## Georgia Avenue NW Dedicated Bus Lane from Barry Place to Florida Ave NW

### SOLICITATION QUESTIONS AND RESPONSES

AMENDMENT 4

Solicitation No.: DCKA-2014-B-0062

**Figure: 150W LED Tear Drop Light Details**

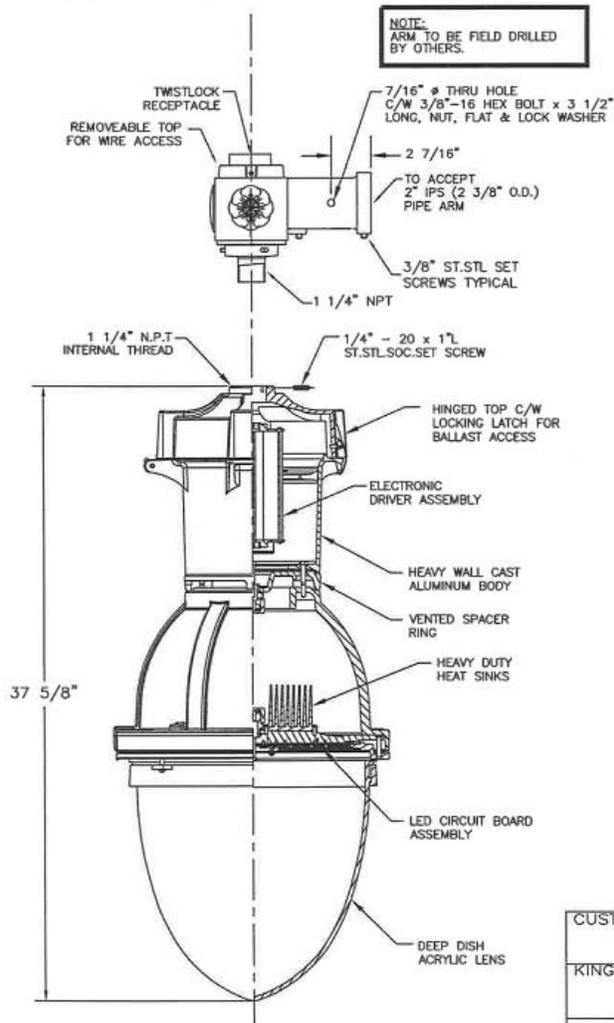
*Replace Specification 57 – page 51 – section 12 with the following specifications for 150 W LED Tear Drop.*

*Replace Pay Item 618 760 with Pay Item 000 506 Unassigned Special Item - EACH- Furnish & Install 150 Watt LED Tear Drop.*

*Line 1280 – Replace Pay Item 618 760 - Furnish and Install 250W HPS Tear Drop Luminaire with 000 506 Unassigned Special Item - EACH- Furnish & Install 150 Watt LED Tear Drop.*
